CHANGE NO. 17 TO THE TECHNICAL SPECIFICATIONS

FACILITY LICENSE NO. DPR-28

VERMONT YANKEE NUCLEAR POWER CORPORATION

DOCKET NO. 50-271

Figure 6.1.1 CORPORATE ORGANIZATION

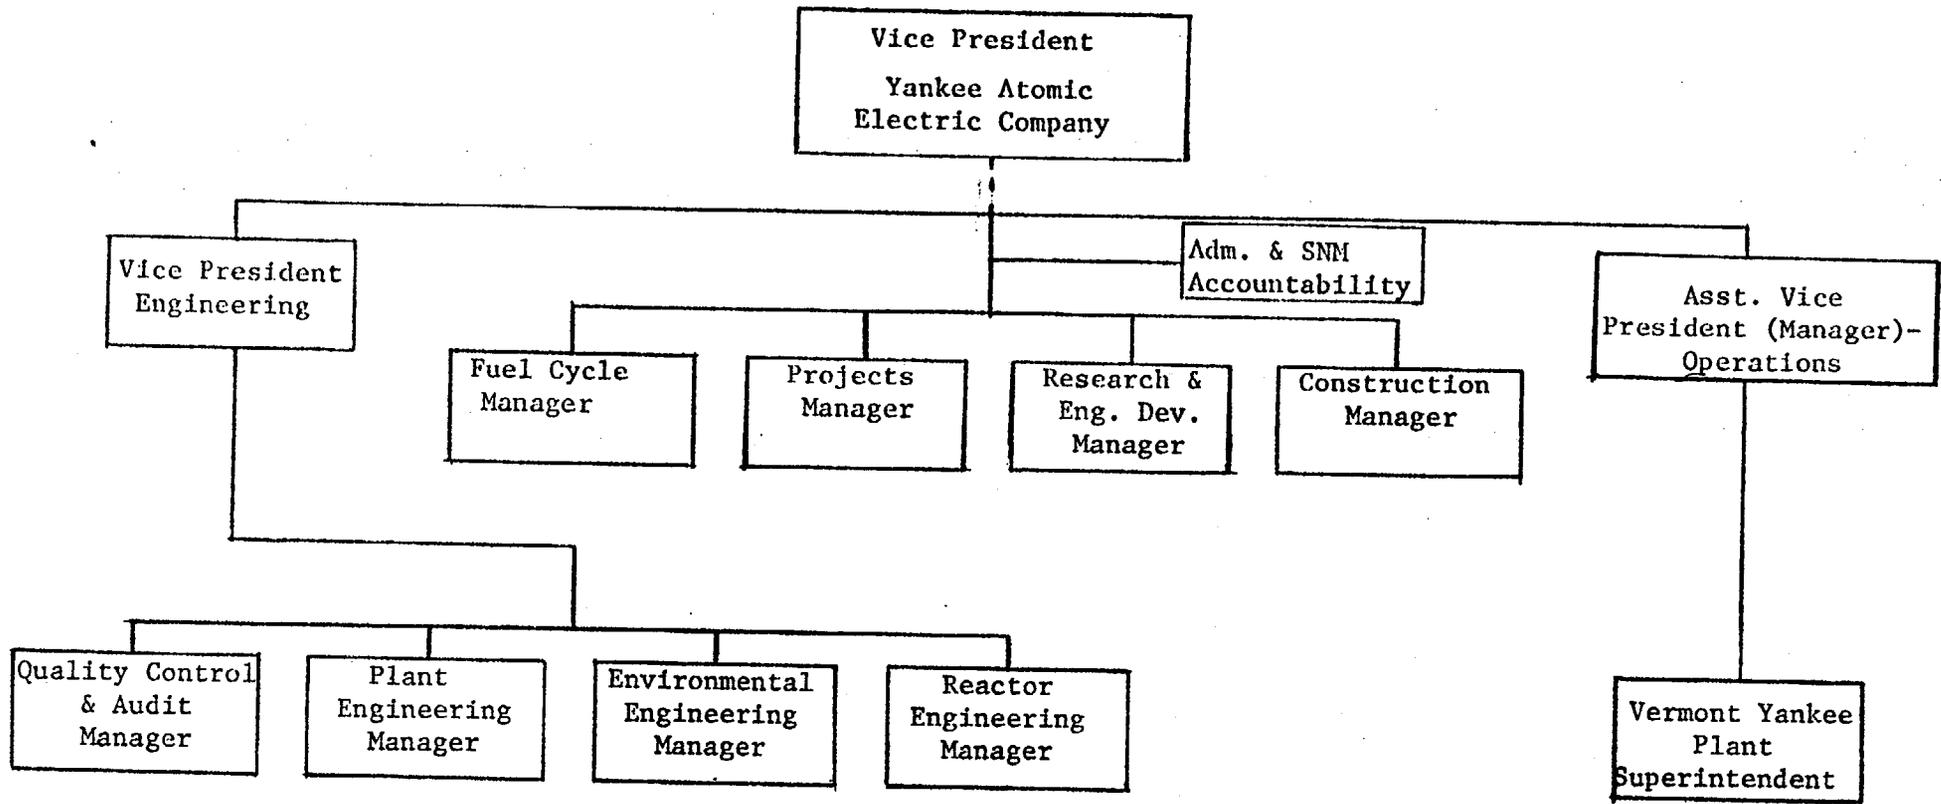
Subsection 6.1 was updated to reflect the current Vermont Yankee organization. Subsection 6.2 was changed to show the combining of the position for Reactor and Computer Supervisor. No changes were

- A. The Plant Superintendent or the Assistant Plant Superintendent has on-site responsibility for the safe and efficient operation of the facility.
- B. The portion of the corporate management which relates to the operation of this plant is shown in Figure 6.1.1.
